Service Action

Code: 19N8

REVISION

Subject	After-Run Coolant Pump
Release Date	February 18, 2020
REVISION SUMMARY	Updated claiming and work instructions: A single part number per criteria will now be used.
Affected Vehicles	U.S.A.: Certain 2012-2017 MY Audi vehicles with a 2.0L TFSI gasoline engine CANADA: Certain 2013-2017 MY Audi vehicles with a 2.0L TFSI gasoline engine <i>Check Campaigns/Actions screen in Elsa on the day of repair to verify that a VIN qualifies for repair under this action. Elsa is the <u>only</u> valid campaign inquiry & verification source.</i> <ul style="list-style-type: none">✓ Campaign status must show “open.”✓ If Elsa shows other open action(s), inform your customer so that the work can also be completed at the same time the vehicle is in the workshop for this campaign.
Problem Description	Power to the electric (after-run) coolant pump was disconnected under Safety Recall 19N4.
Corrective Action	Install a new electric (after-run) coolant pump and update ECM software.

Installing new after-run coolant pump -V51-

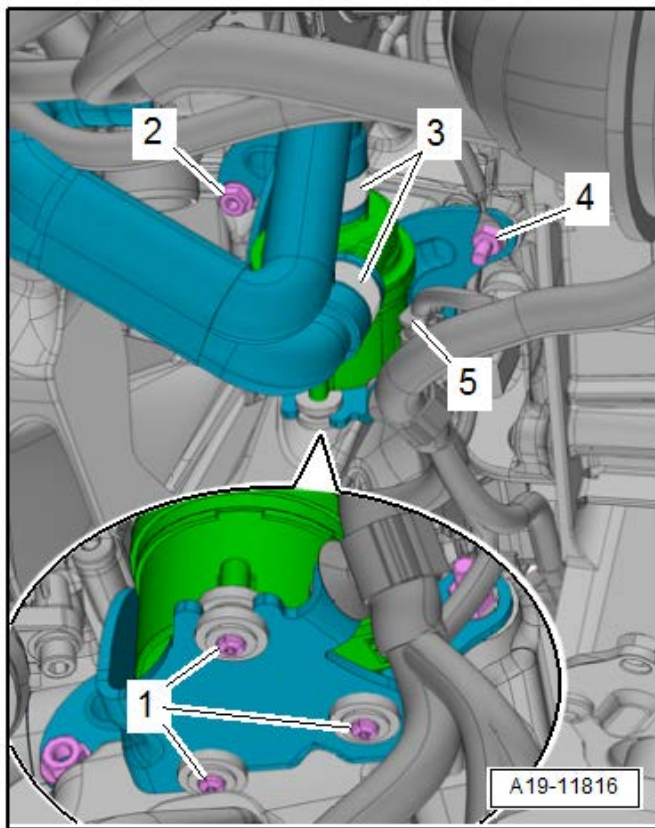
Due to the new location of the connector on the new pumps, the after-run coolant pump wiring harness <arrow> may have to be routed so it does not come into contact with the pump coolant hose.

When installing nut <2>, a swivel socket may not clear the coolant hose fitting.

- Attach securing nut to index finger using some sealant cord ("dum-dum").
- Position securing nut on stud with index finger.
- If necessary, hold securing nut from above with a flat-bladed screwdriver and at the same time screw on securing nut with index finger until a socket can be used on the nut.

- Install new after-run coolant pump/bracket assembly.
- Install nut <2> and torque to 9 Nm.
- Install double bolt at location <4> and torque to 9 Nm.
- Install ground wire.
- Install nut at location <4> and torque to 9 Nm.
- Install hoses and secure hose clamps <3>.
